WAMBO COAL PTY LTD

NORTH WAMBO UNDERGROUND MINE LONGWALL 10A MODIFICATION

RESPONSE TO SUBMISSIONS

December 2014

APPENDIX A
ADDITIONAL GROUNDWATER MODEL INFORMATION

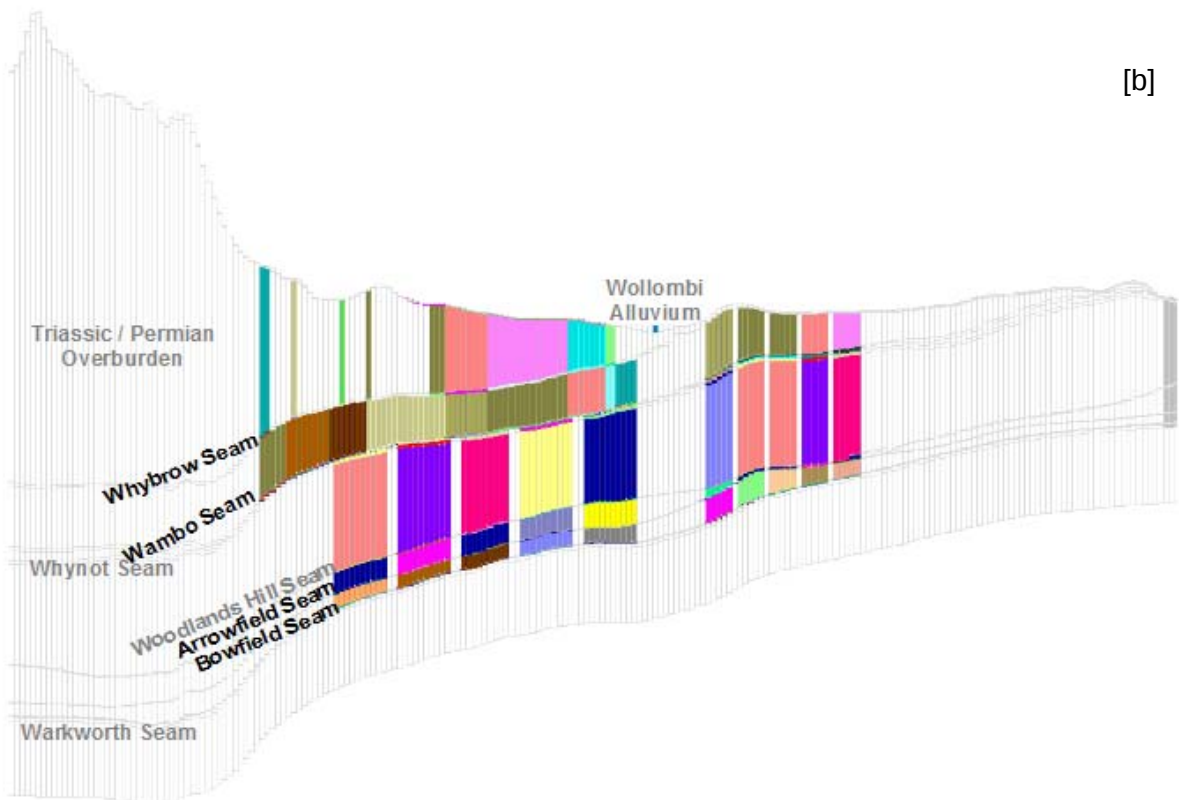
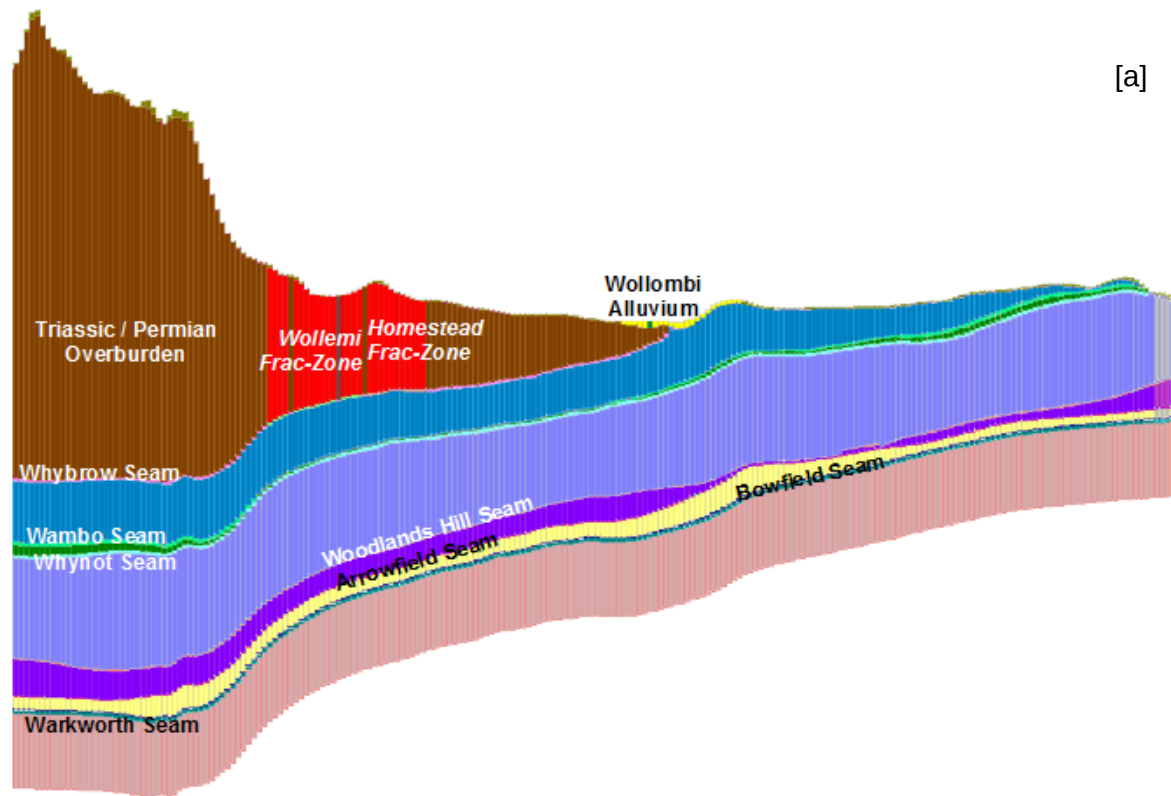
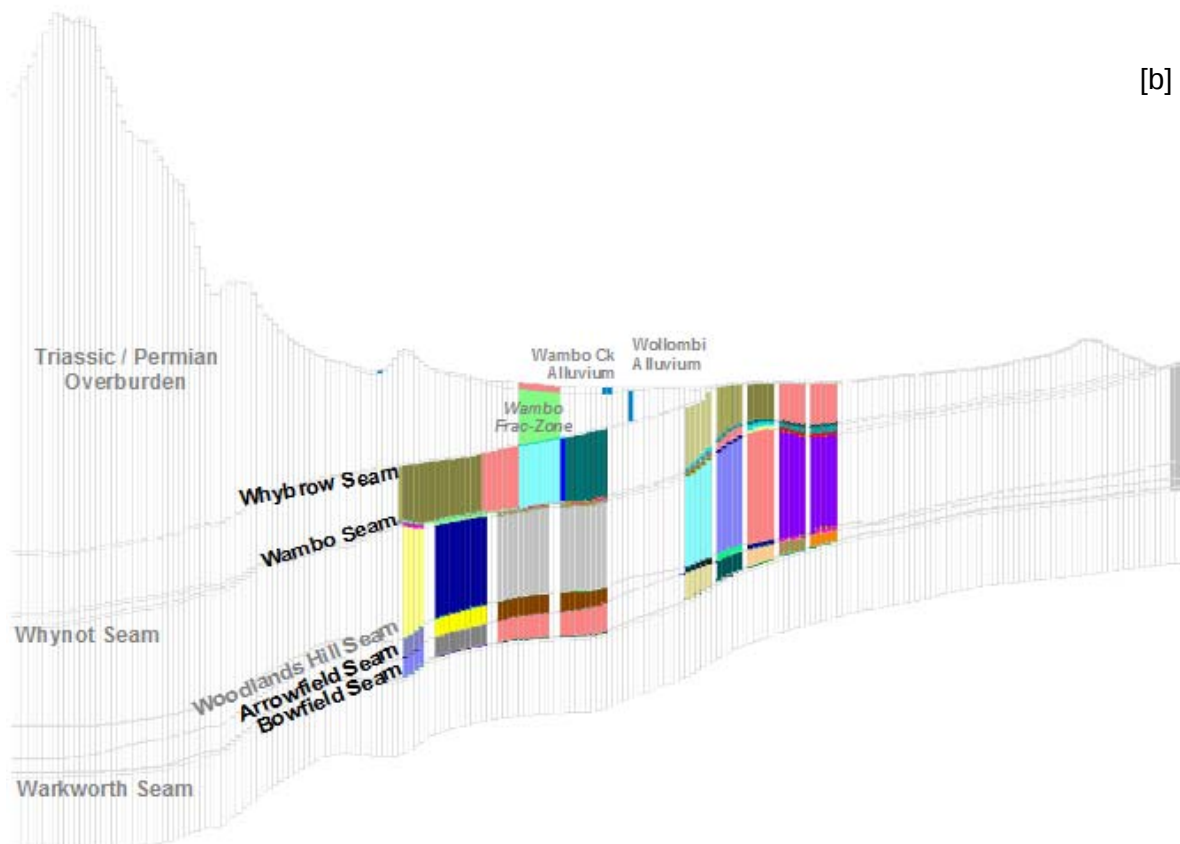
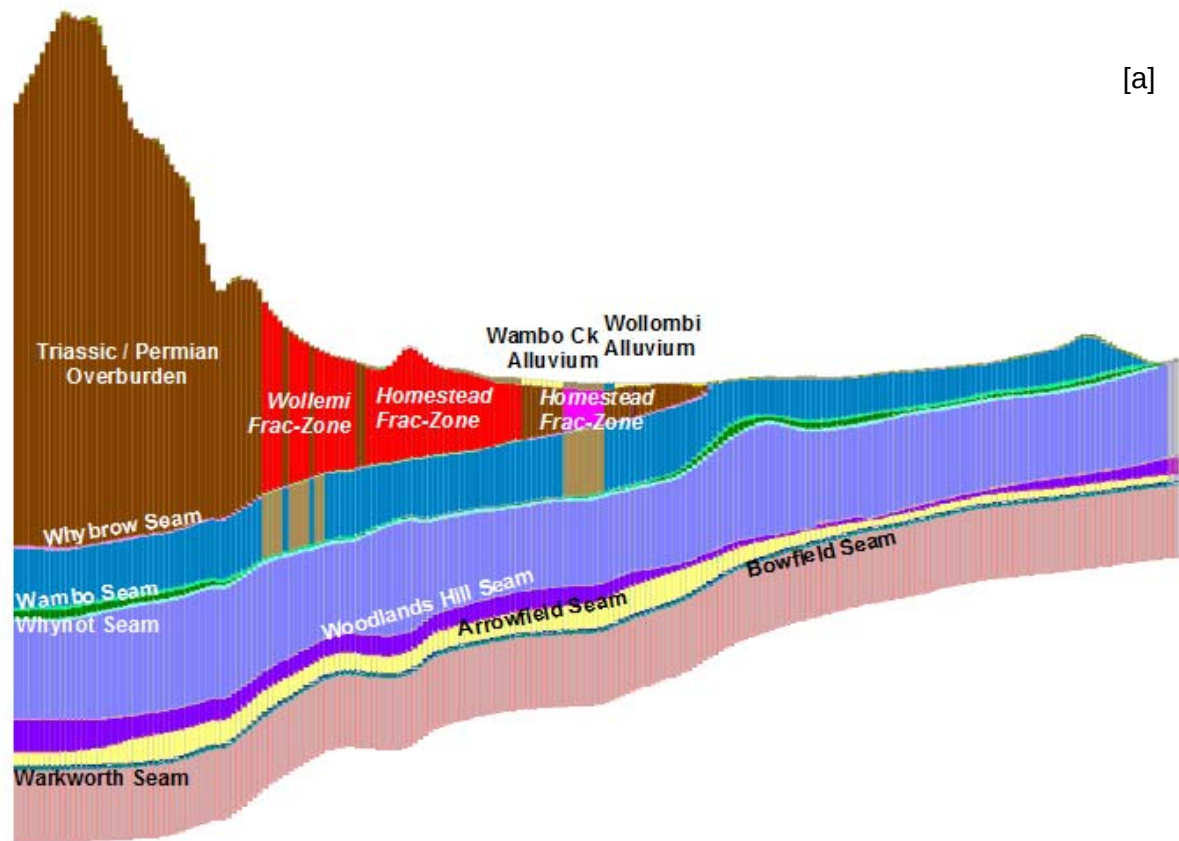
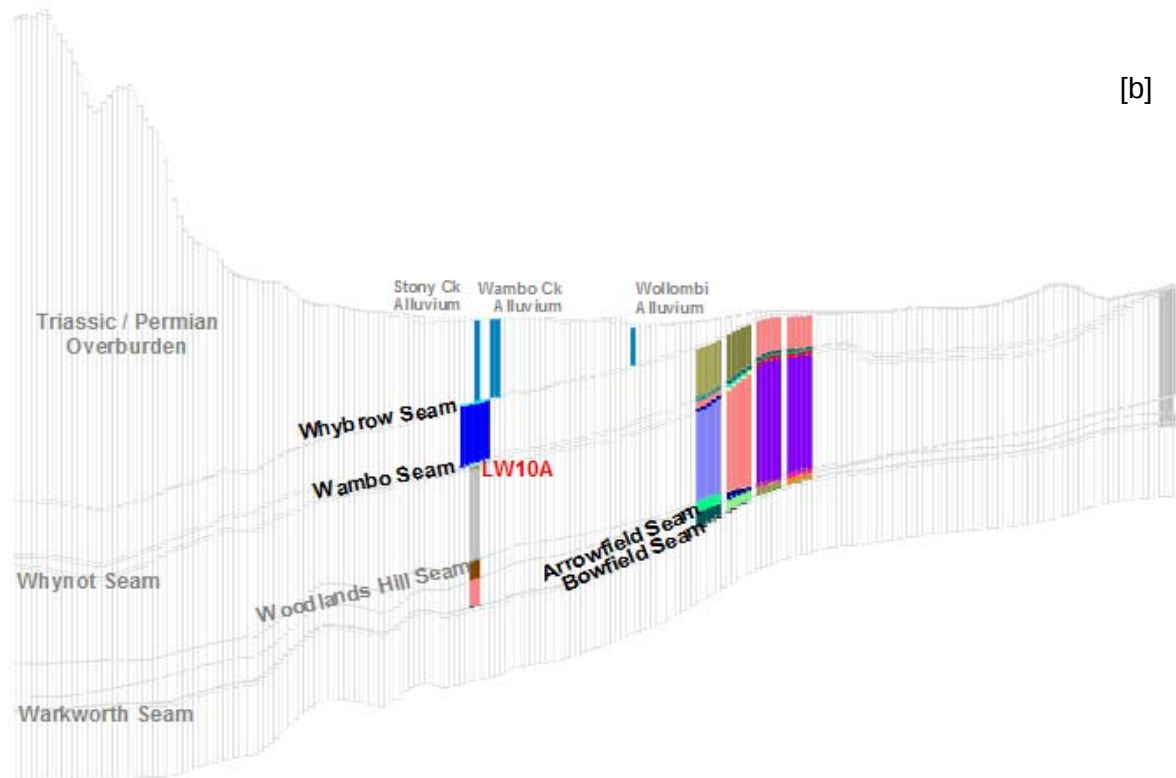
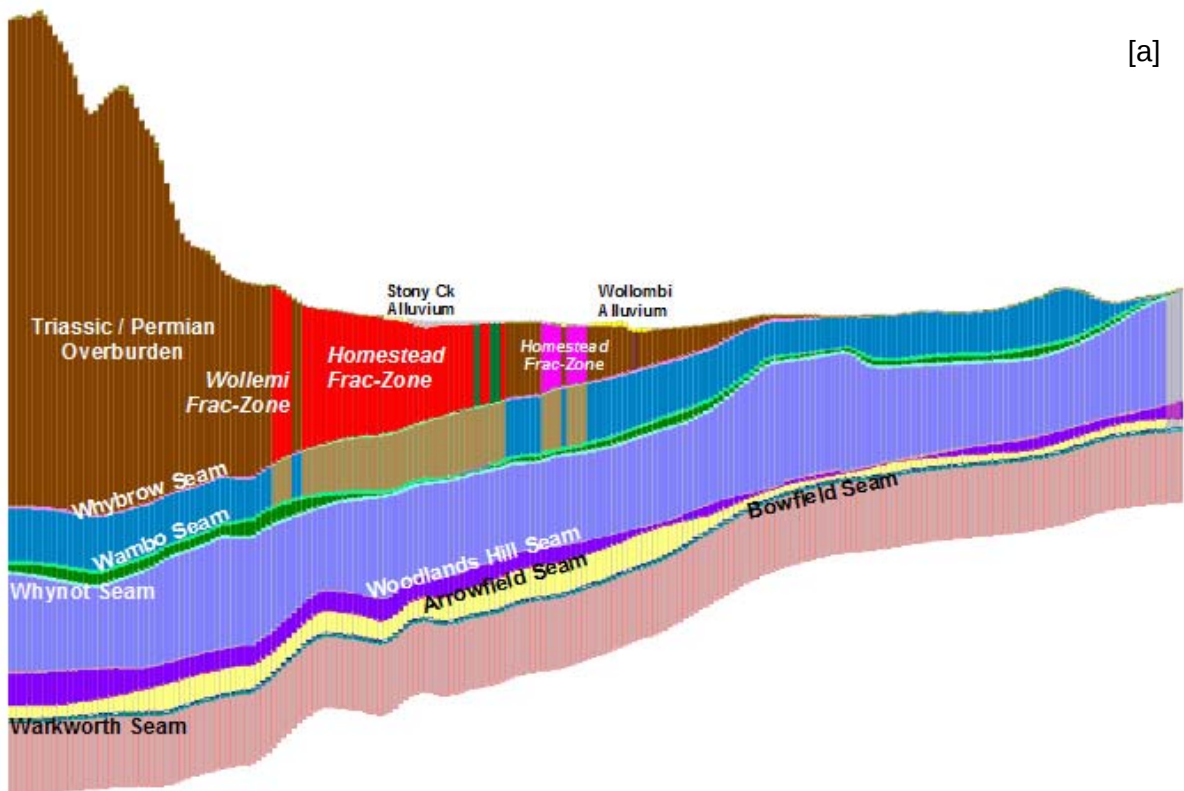
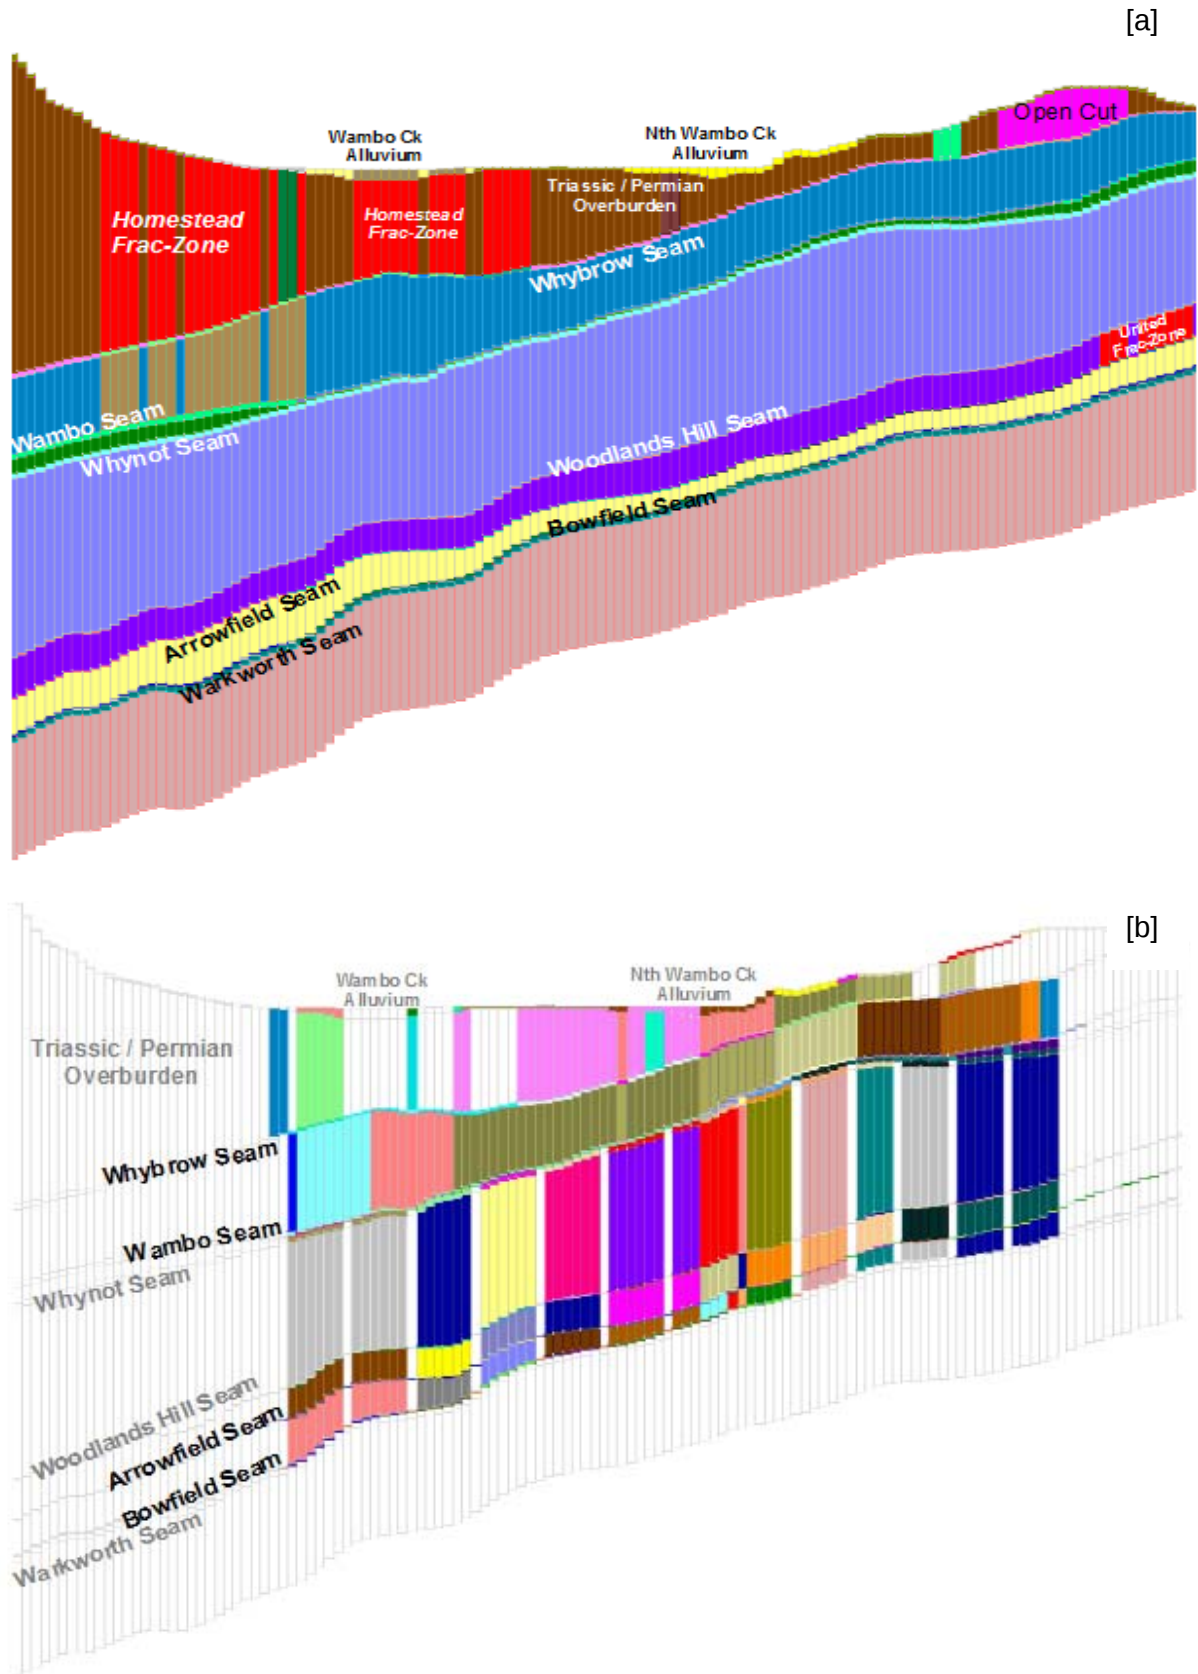
Comment	Response
Department of Primary Industries (DPI) (Including NSW Office of Water [NOW]) The NOW stated that a cumulative assessment of the subsidence impacts from the proposed Longwall 10A and the <u>future approved extraction proposed in two underlying seams (Arrowfield and Bowfield Seams) had not been completed.</u> The NOW requested further detail on the fracturing heights from mining the Wambo Seam in Longwall 10A, in particular with respect to whether the proposed extraction was considered as a multi-seam extraction for the purpose of deriving fracture zone extent given the existing approval for the underlying Arrowfield and Bowfield Seams. The NOW requested a series of slices (diagrammatically) in both horizontal and lateral extent for the various model layers displaying how the fracturing heights and hydraulic conductivities have been applied.	
	The NOW's statement that cumulative assessment of the Arrowfield and Bowfield Seams was not considered in the Groundwater Assessment is incorrect. As stated on page 25 of the Groundwater Assessment (Appendix B of the EA): <i>The mine workings represented in the model include:</i> • <i>Homestead and Wollemi Underground (Wambo) (completed prior to steady state calibration period);</i> • <i>South Bates-Whybrow Seam Underground (Wambo);</i> • <i><u>Arrowfield and Bowfield Underground (Wambo);</u></i> ... As requested by the NOW, HydroSimulations has prepared five cross-section slices of the model with the locations of three east-west and two north-south lines shown in Figure A1 (Appendix A). These slices are provided in Figures A2 to A6. These figures show the extent of adopted fracturing in the groundwater model. The upper figure shows host (pre-mining) permeabilities and permanent fracture zones. The lower figure shows fractured zones that grow dynamically as the simulation of mining progresses in the model. Figures A2 to A6 confirm that the fracturing represented in the model is definitely conservative, as it has been assumed that all intervening interburden zones between mined coal seam pairs are fully fractured. Table 8 of the Groundwater Assessment (Appendix B of the EA) listed the permeabilities of fractured zones for the North Wambo, United and Homestead mines. Table A1 (Appendix A) provides the same information for the fractured zones applied in the model above the proposed Arrowfield and Bowfield workings. Therefore, the NOW's concerns as to the lack of consideration of connective cracking have been directly addressed.
